**Amendments to the Drawings:**

**Remarks:**

This application has been reviewed carefully in light of the Office Action mailed March 5, 2009. The specification was objected to as failing to provide proper antecedent basis for the claimed subject matter. Claims 13  
5 and 14 were objected to for informalities. Claims 16-17 were rejected under 35 U.S.C. § 112, second paragraph, as being indefinite.

Figure A

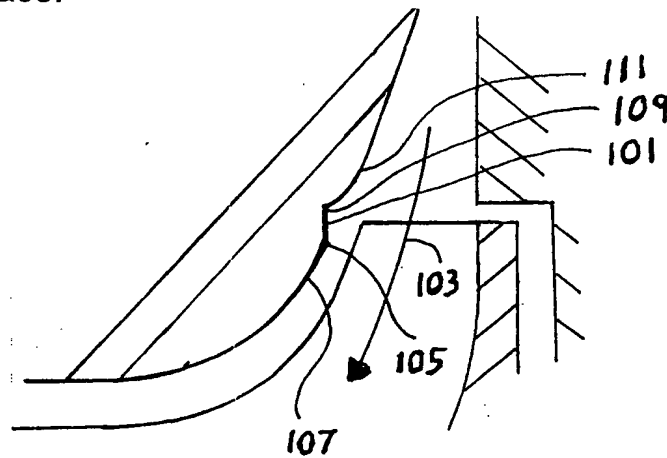
Claims 16 and 17 have now been amended. In figure A, below, the applicant depicts a discontinuity under claims 1 and 16 and 17 at the trailing edge of a blade. The discontinuity shown is the one depicted in Fig. 4d of the application.

Per the last clause of claim 1, figure A depicts a discontinuity forming a downstream-facing blocking face 101 adapted to impede an upstream flow of gas between the shroud and the wheel, the blocking face extending across the gas flow path to form a sharp edge 105 connecting the blocking face to a smoothly curving surface 107 along the gas flow path upstream of the blocking face (i.e., upstream of the discontinuity).

Per claims 16 the blocking face 101 forms a second sharp edge 109 on an opposite side (i.e., a downstream side) of the blocking face 101 from the first sharp edge 105, the second sharp edge 109 connecting the blocking face 101 to a second smoothly curving surface 111 that is downstream of the blocking face (i.e., downstream of the discontinuity).

In claim 4, the above-described (first) discontinuity is differentiated from a second discontinuity (not shown below). In similar form to claims 16, claim 17 (which depends from claim 4) recites that the first-discontinuity blocking face 101 forms a second sharp edge 109 on an opposite side (i.e., a downstream side) of the first-discontinuity blocking face 101 from the first sharp edge 105 of the first-discontinuity blocking face 101, the second sharp edge 109 connecting the first-discontinuity blocking face 101 to a

second first-discontinuity smoothly curving surface 111 downstream of the first blocking face.

In light of the amendments and the preceding discussion, the applicant respectfully requests the rejection of claims 16 and 17 under 35 U.S.C. § 112, be withdrawn.

Figure B

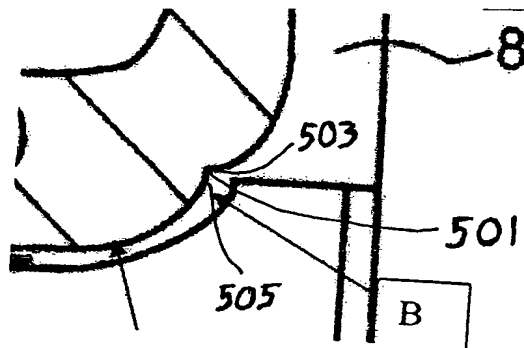
The applicant notes with appreciation the figures incorporated into the Office Action, which clarify the related discussion. The drawing from Mitsubori et al., as shown on page 9 of the Office Action, is replicated in part below as Figure B, with additional notations. In the drawing, the depicted discontinuity is made of a dimple having a single sharp edge 501 at the base of the dimple, an upstream-facing face 503 downstream of the sharp edge, and a downstream-facing face 505 upstream of the sharp edge. Mitsubori et al. fails to disclose a sharp edge connecting a downstream-facing blocking face to a smoothly curving surface upstream of the blocking face.

Because the cited reference fails to disclose the features of claim 1, 15/1 and 18, the Office Action fails to assert a prima facie case of anticipation, and the applicant respectfully requests the rejections of claims 1, 15/1, and 18 under 35 U.S.C. § 102(b) be withdrawn.

Figure D: Fabri et al.

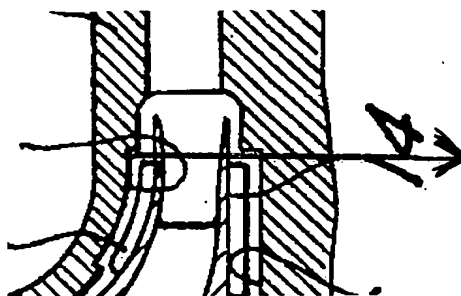
25 The Fabri et al. patent clearly fails to disclose a sharp edge that connects a downstream-facing blocking face to a smoothly curving surface upstream of the blocking face. While it is not entirely clear which sharp edge is identified in Fabri et al., there is no sharp edge that connects a smoothly curving surface on the upstream side of the edge to a face that points at all downstream by any reasonable definition.

The Office Action recites that both Yoshinaga et al. and Fabri et al. disclose downstream facing faces, and notes that during examination  
5 claims must be interpreted as broadly as their terms reasonably allow. Portions of the figures identified in the Office Action are reproduced below, with lines added showing the direction that walls in the vicinity of the trailing edges are facing. In each case these walls are facing directly across the flow. There is no portion of the passageway that is angled to suggest that  
10 the wall is in a downstream-facing direction. Thus the applicant respectfully notes that there is no reasonable interpretation of the term downstream-facing face that applies to these figures.

Because the cited references fail to disclose a downstream-facing blocking face, the applicant respectfully requests the rejections of claims under Grounds 2-6 be withdrawn.
